## Summary of Items Discussed in 2/2020 APSEC Discussion Forum on 29 May 2020

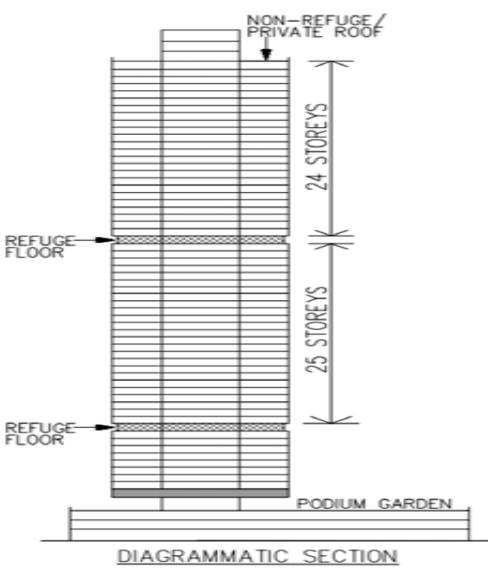
Items proposed by Convenors for Discussion	Summary of Discussion and BD's Responses
	<b>Items raised by HKIA</b>	
1.	<p><b><u>Innovative Building Designs with Large Projecting/Overhanging Features</u></b></p> <p>According to paragraph 6 of PNAP APP-19, save for the areas covered by projecting features which provide a weather-protected shelter capable of functional use, it is accepted that where there is no objection from the relevant government departments and the clear height of the projecting feature is more than 7.5m above the covered areas, the covered areas are not required to be included in GFA calculation if they satisfy the following criteria:</p> <p class="list-item-l1">(a) The ratio of horizontal width of the covered area to the clear height of the projecting features above the covered area is not less than 1:8, <b>OR</b></p> <p class="list-item-l1">(b) Access to the covered area is not possible and abuse is unlikely.</p> <p>Based on the above, we would like to enquire the following:</p> <p class="list-item-l1">(i) For criteria (a), where the covered area is provided along pavement accessible to pedestrian and is not abutted with retail use, it is not required to be included in GFA calculation if it <b>can satisfy the 1:8 requirement</b> (Sketch A refers).</p>	<p>BD advised that whether the concerned covered areas could be exempted from GFA calculation would depend on the overall building design as well as the chance of abuse, and hence had to be considered on a case basis.</p>

(where  $w:h$  is not less than 1:8 and  $h$  is not less than 7.5m)

(ii) For criteria (b), if planters and/or water features are provided under the projecting/overhanging features, which renders the covered area **non-functional** and **access is not possible** (save for maintenance purpose), the covered area is not required to be included in GFA calculation (Sketch B refers).

(where  $h$  is not less than 7.5m)

<p>Please advise if our above understanding is correct.</p>	
2.	<p><b><u>Refuge Floors</u></b></p> <p>Clause B18.1 of FS Code 2011 states that “... <i>refuge floors should be provided for all buildings exceeding 25 storeys in height above the lowest ground storey, at not more than ... 25 storeys ... for buildings ... in other Use Classifications from any other refuge floor ...</i>”. Based on the above, we opine that the following schematic section is a correct interpretation of the requirement where there can be 25-storeys of residential or office accommodation <b>between the refuge floors</b>, i.e. the refuge floor itself is not counted into the 25 storeys as stipulated in the clause. Please advise if our interpretation is correct.</p>  <p>NON-REFUGE PRIVATE ROOF</p> <p>REFUGE FLOOR</p> <p>REFUGE FLOOR</p> <p>PODIUM GARDEN</p> <p>24 STOREYS</p> <p>25 STOREYS</p> <p>DIAGRAMMATIC SECTION</p>	<p>For the scenario provided in HKIA's sketch, the refuge floor needs not be counted towards the requirement of “25 storey” under Clause B18.1 of FS Code 2011.</p>

### PRESCRIBED WINDOW DIAGRAM OF BLOCK B

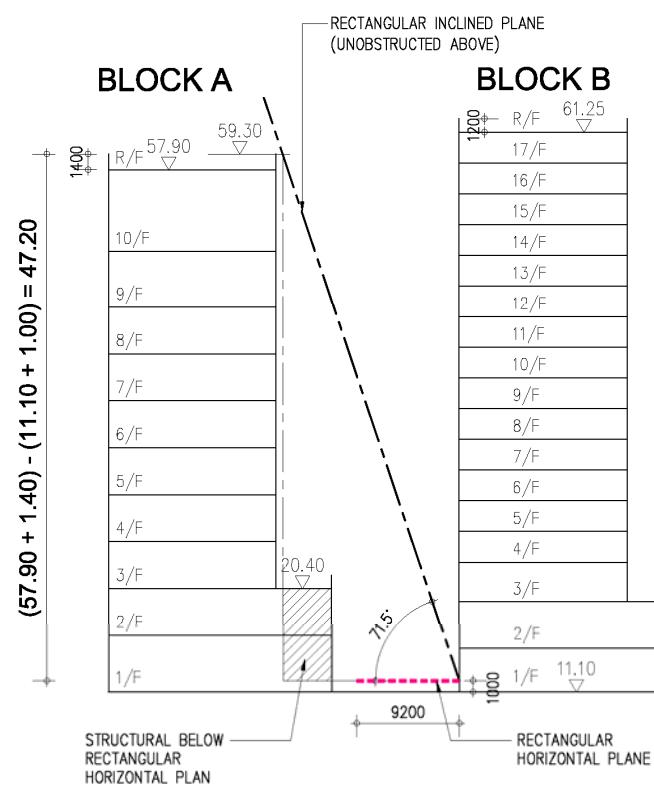
<p>the lavatories. Enclose herewith a diagram illustrating the situation and please confirm if our understanding is correct.</p> 	
15.	<p><b><u>Minimum Requirements of Window – B(P)R 31</u></b></p> <p>According to B(P)R 31(3), the “rectangular horizontal plane” means a rectangular plane at the level of the sill of the window having the minimum area and minimum dimension prescribed by paragraph (2).</p> <p>Given that the requirements of rectangular horizontal plane as mentioned under B(P)R 31(2) and B(P)R 31(3) are already complied, is it allowed to have structure below this inclined plan as required under B(P)R 31(1)?</p> <p>Attached diagram refers:</p>	<p>BD advised that the scenario is acceptable provided that the space above the rectangular horizontal plane measuring 2.3m x 9.2m is uncovered and unobstructed and no part of any building protrudes above the inclined plane according to B(P)R 31(1)(b) &amp; (c).</p>

MINIMUM REQUIRED LENGTH OF RECTANGULAR INCLINED PLANE  
 ( FOR 1/F HABITABLE ROOM WINDOW FACING BLOCK A )  
 $= [(57.90 + 1.40) - (11.10 + 1.00)] / \tan 71.5^\circ$   
 $= 15.793\text{m}$

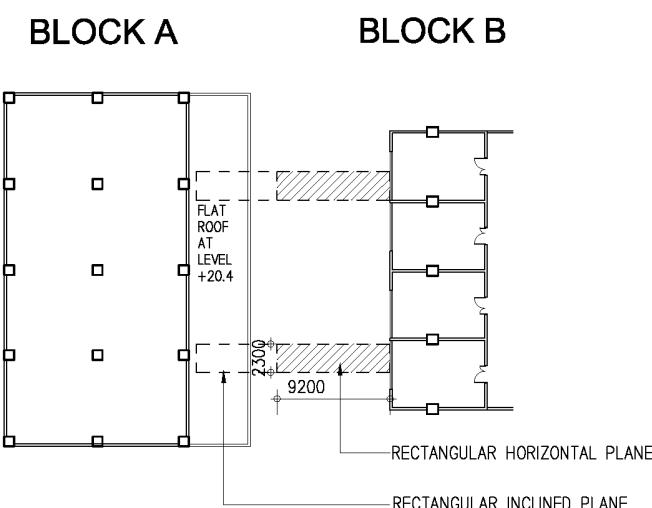
14.	<p><b><u>Location of Temporary Refuge Spaces</u></b></p> <p>Pursuant to the commentary of Clause B30.1 of FS Code 2011, “<i>no exit or accommodation (except pipe duct, building services room or the like not to be used in case of emergency) should be opened off directly to the temporary refuge space in Examples (c) &amp; (d) of Diagram B6.</i>”</p> <p>Our understanding is that there is no accommodation in the male/female/accessible lavatories and they would not be used in case of emergency. In this regard, “the like” as mentioned above should include</p>	<p>BD advised that exits of lavatories should not be opened off to the temporary refuge space.</p>
